**Comanche Peak Nuclear Power Plant, Units 3 & 4  
COL Application**

**FSAR Revision1**

**Update Tracking Report**

**Revision 2**

Figure 2.5.5-205 Post-Construction Cross Section D-D'

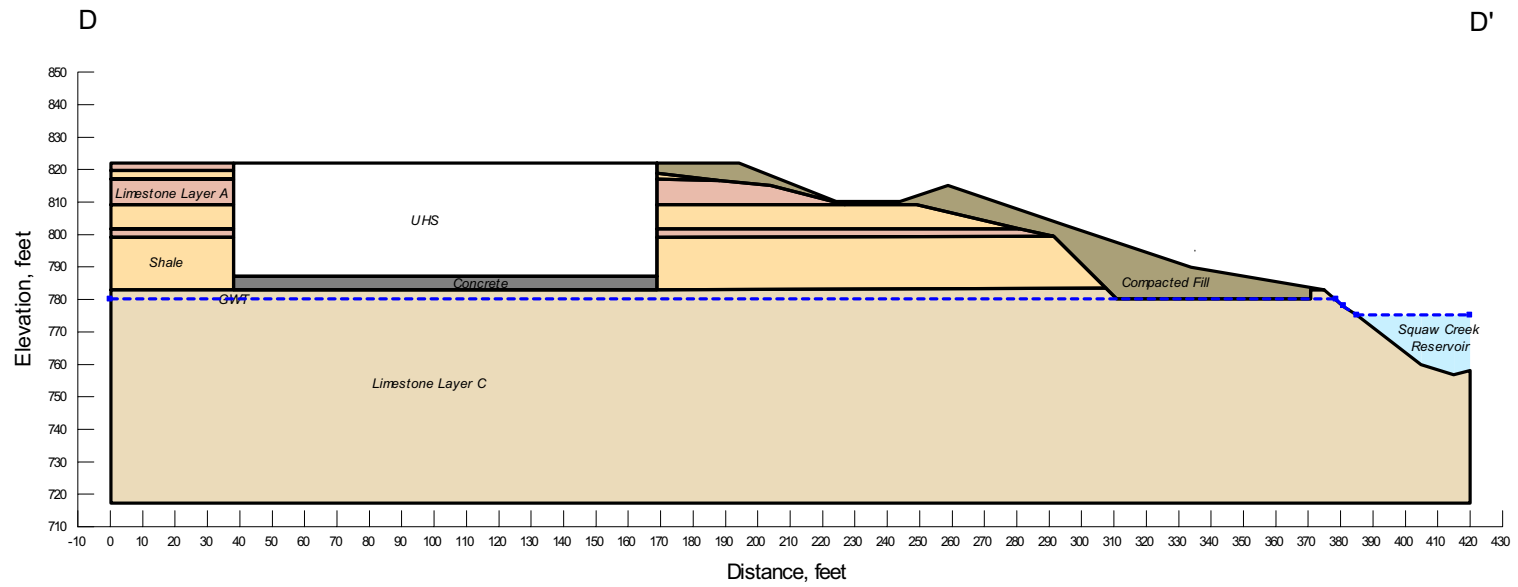
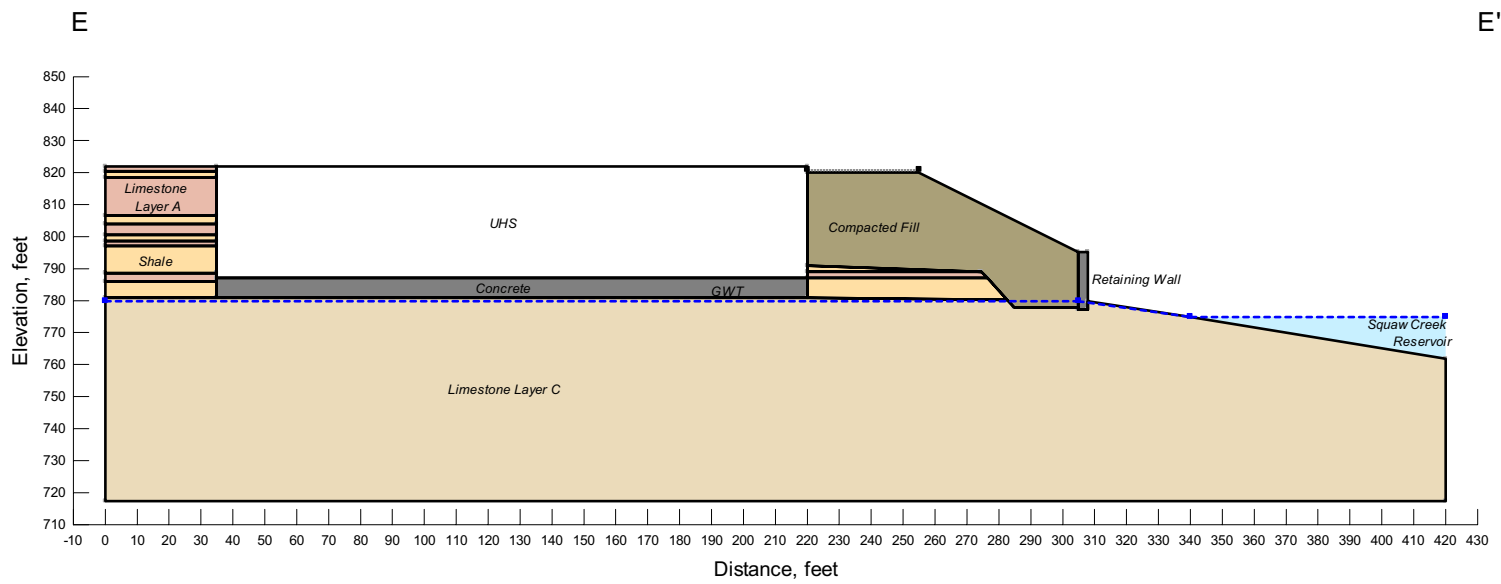
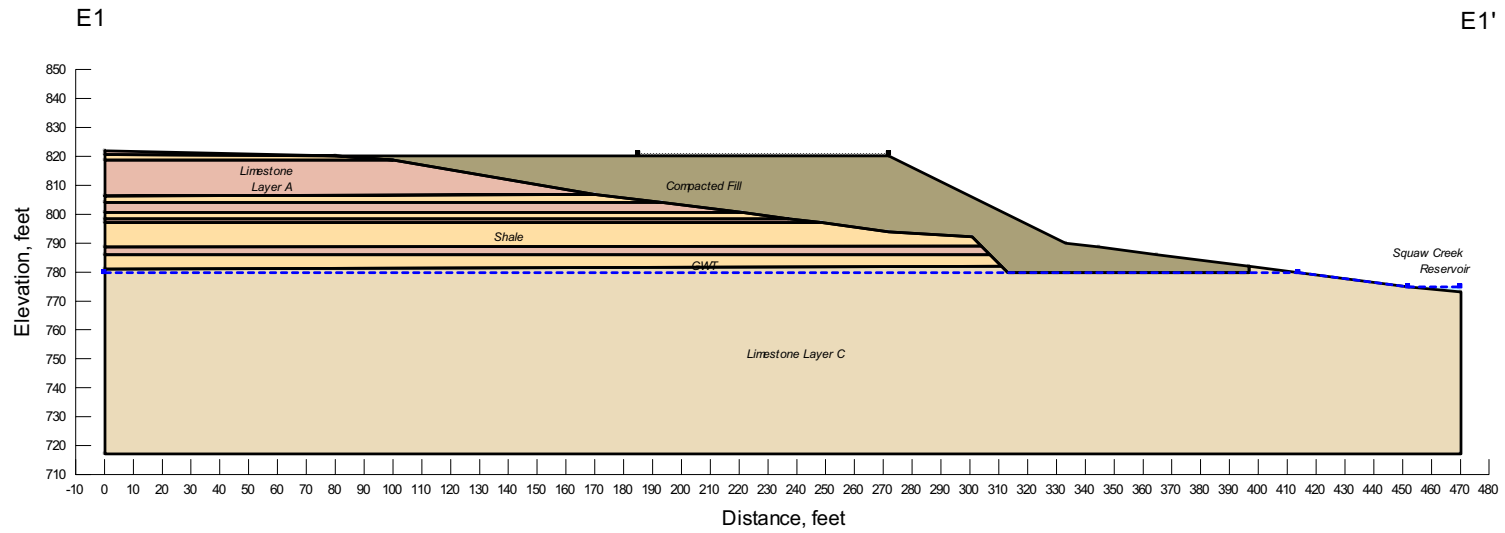
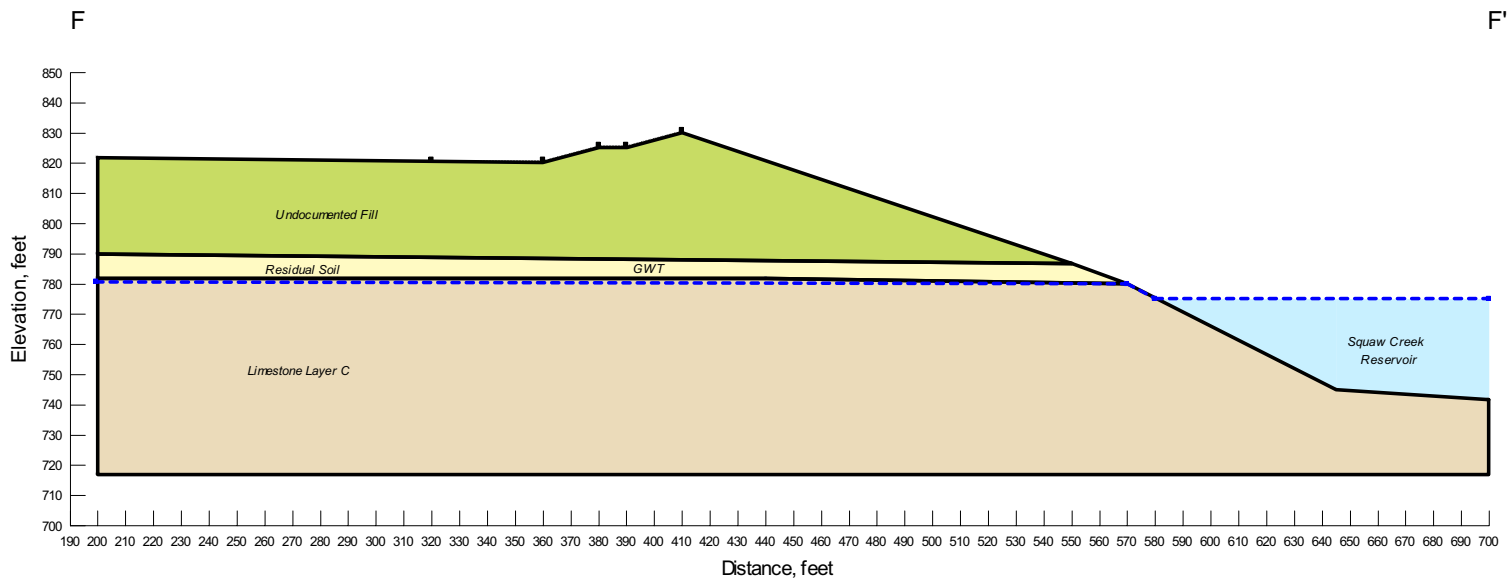
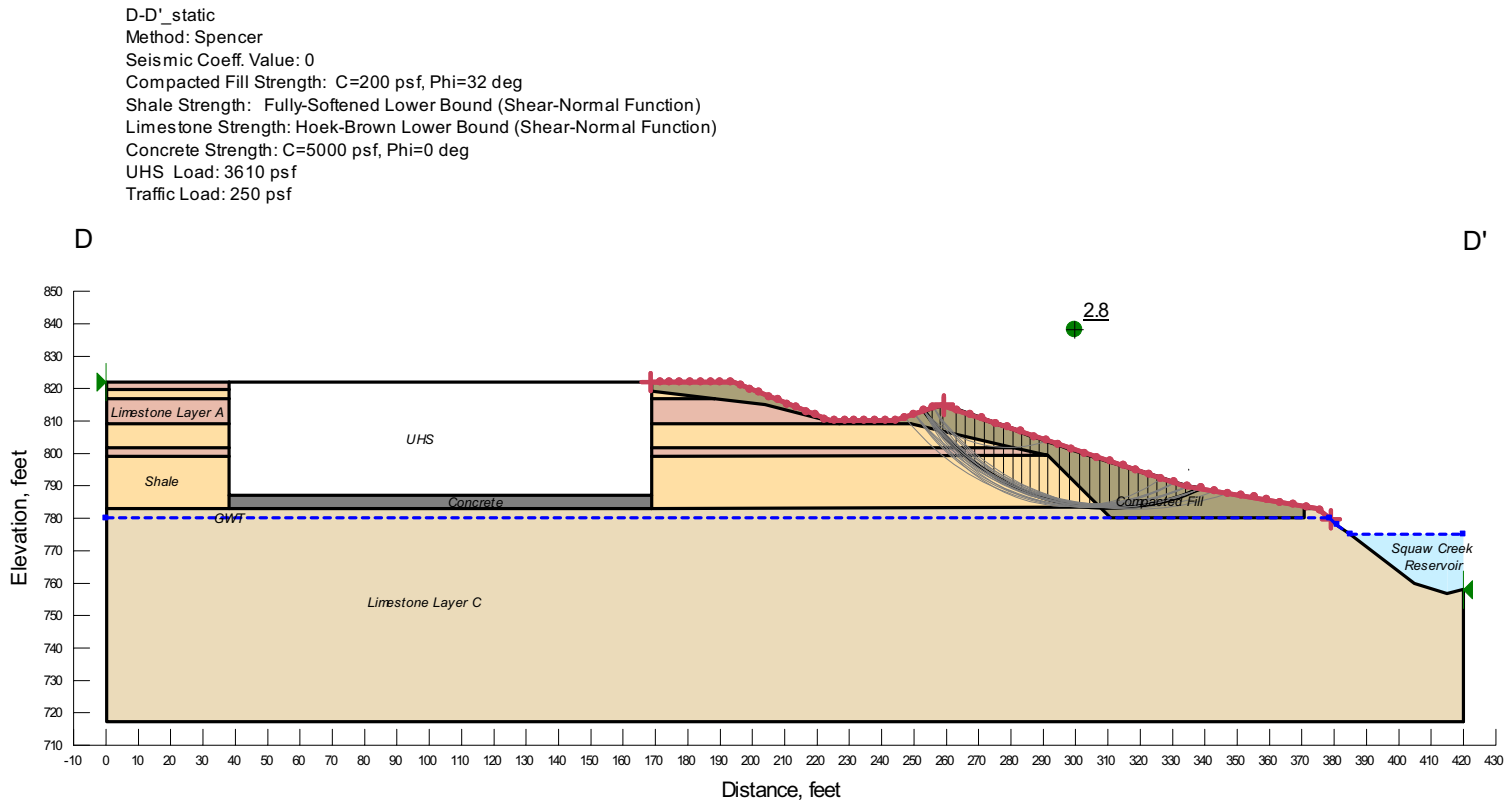
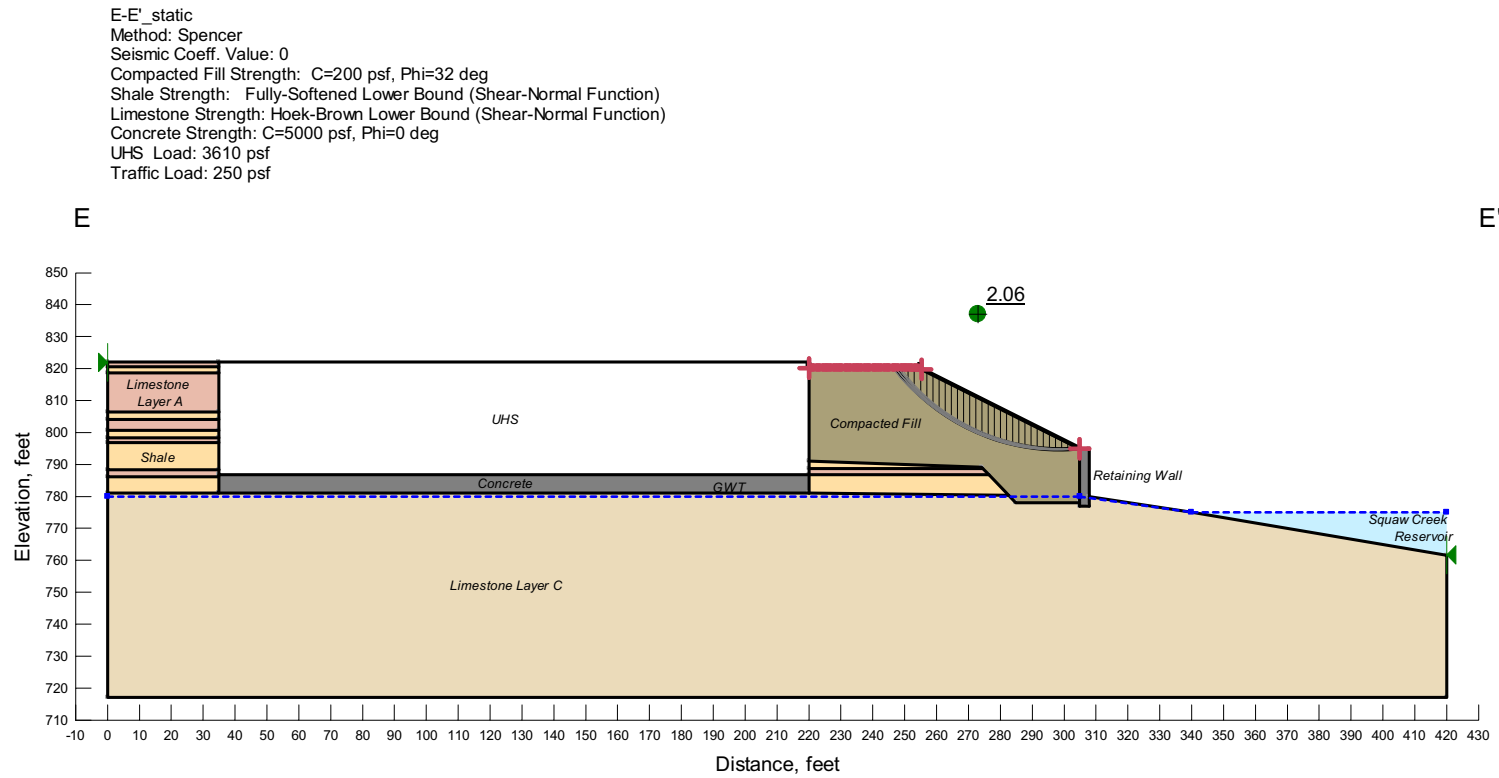
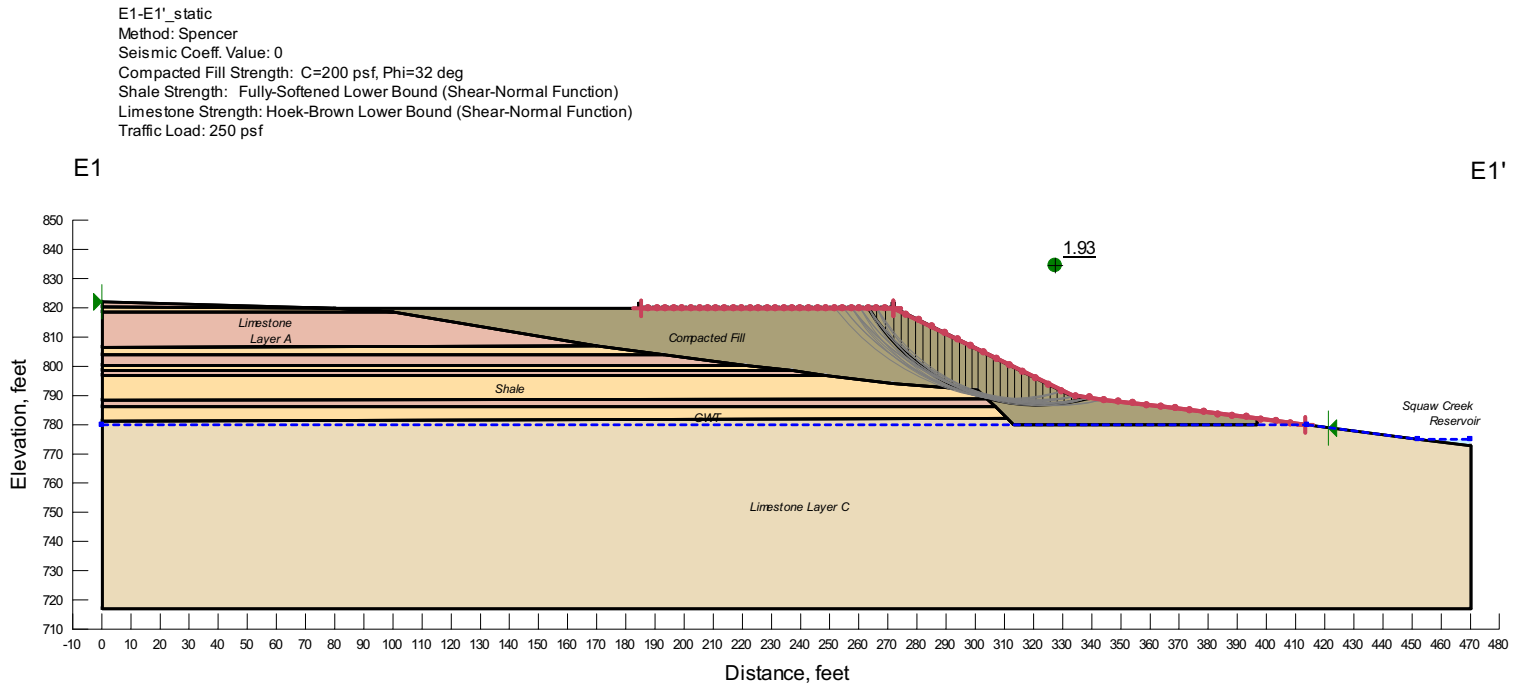
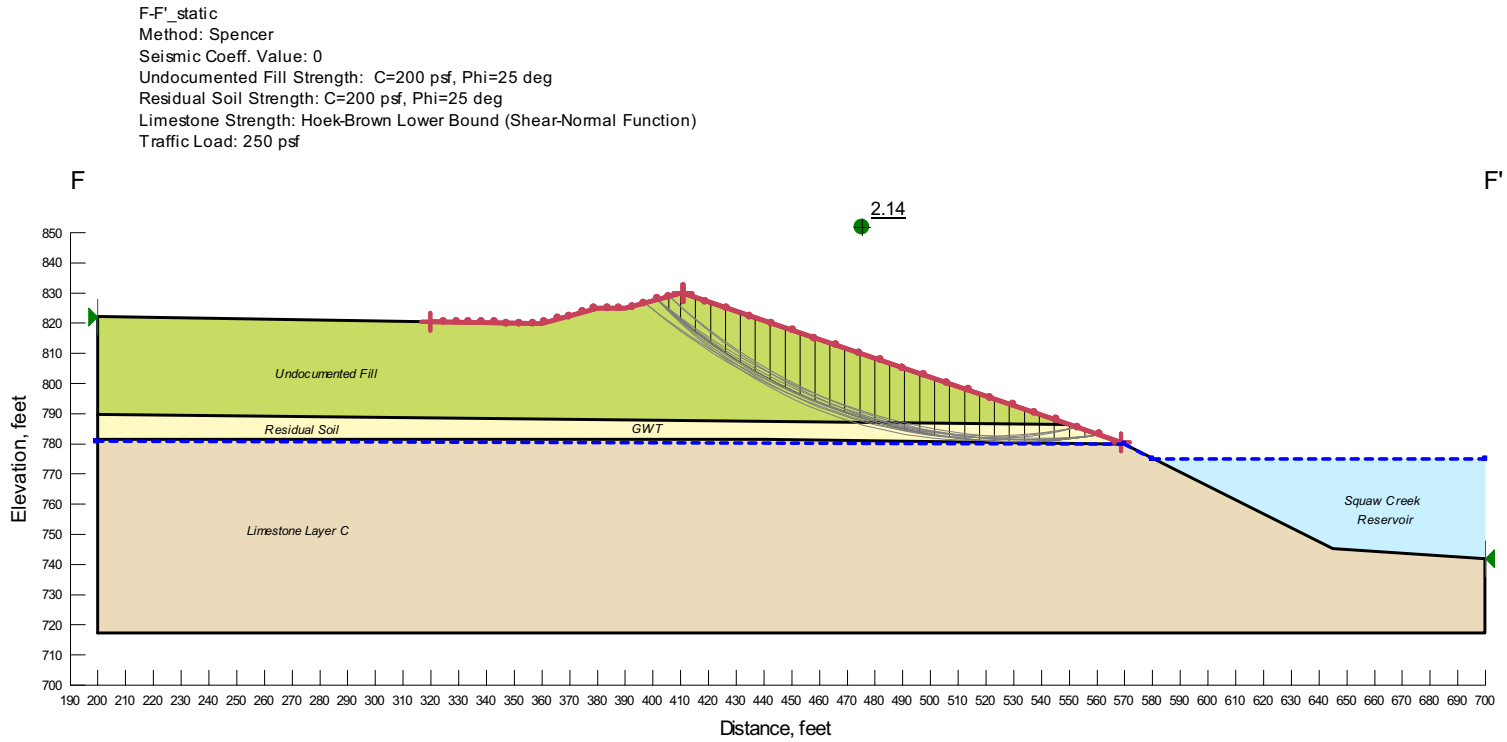
Change ID No.	Section	FSAR Rev. 1 Page*	Reason for change	Change Summary	Rev. of FSA R T/R
CTS-00921	Figure 2.5.5-205 through 2.5.5-212	-	Revised to clarify geologic layers	The colors related to soil on the figures are revised, to be consistent with the revision to figures in provided for RCOL2_02.05.05-1	2

**Figure 9.2.4-1R Potable and Sanitary Water System Flow Diagram**

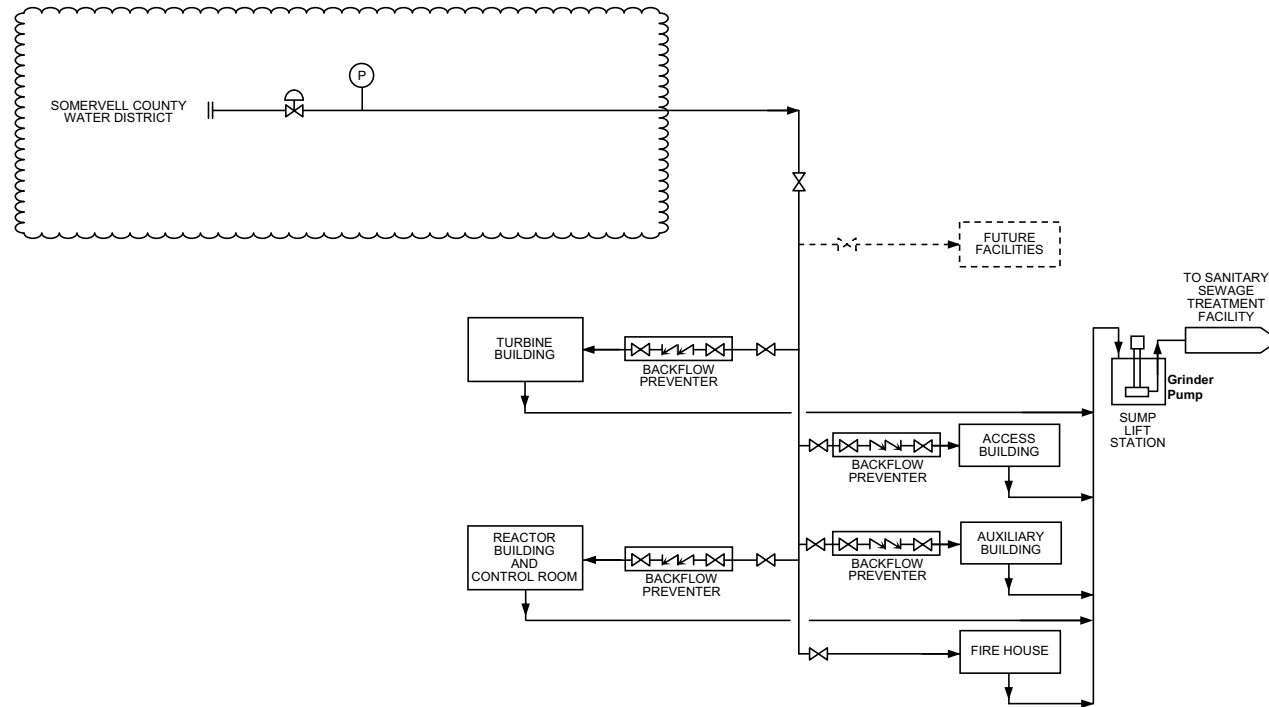
Change ID No.	Section	FSAR Rev. 1 Page*	Reason for change	Change Summary	Rev. of FSAR T/R
				2" will be removed	
RAI GEN-09	Figure 9.2.4-1R (Sheet 1 of2)	9.2-28	Response to RAI GEN-09 Luminant Letter No. TXNB-10013 Date 2/24/2010	Added (sheet 1 of 2) to account for above new figure  The title of this figure will be modified in the next UTR to comply with the DCD  New title: "Potable and Sanitary Water System Flow Diagram" to reflect the DCD  In additon "Sheet 1 of 2" will be removed.	-
CTS-01109	Figure 9.2.4-1R	9.2-28	Errata	Corrected figure title.	2
CTS-01109	Figure 9.2.4-201	9.2-29	Errata	Corrected figure number and title.	2

Figure 9.2.4-201 Sanitary Water System Flow Diagram

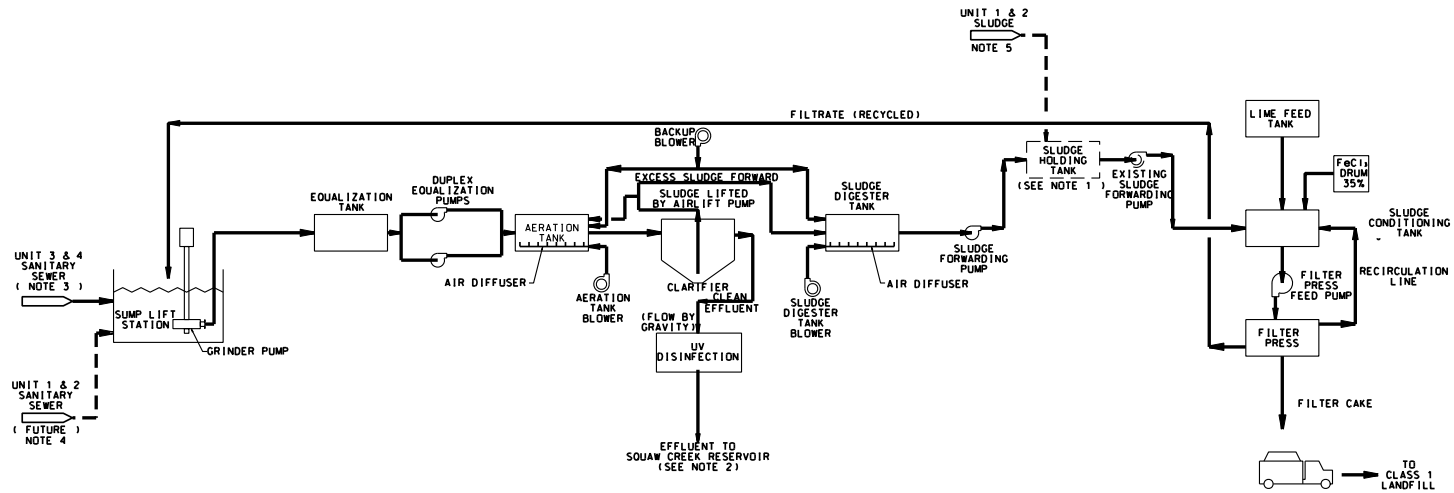
RAI GEN-09	Figure 9.2.4-2R (Sheet 2 of 2)	9.2-29	Response to RAI GEN-09 Luminant Letter No. TXNB-10013 Date 2/24/2010	Added new figure to FSAR Ch 9 to supplement Figure 9.2.4-1R, this figure was not added correctly and the name will be changed to 9.2.4-201 in the next UTR, in addition Luminant requests that the title be changed to "Sanitary Water System Flow Diagram" and "sheet 2 of	-
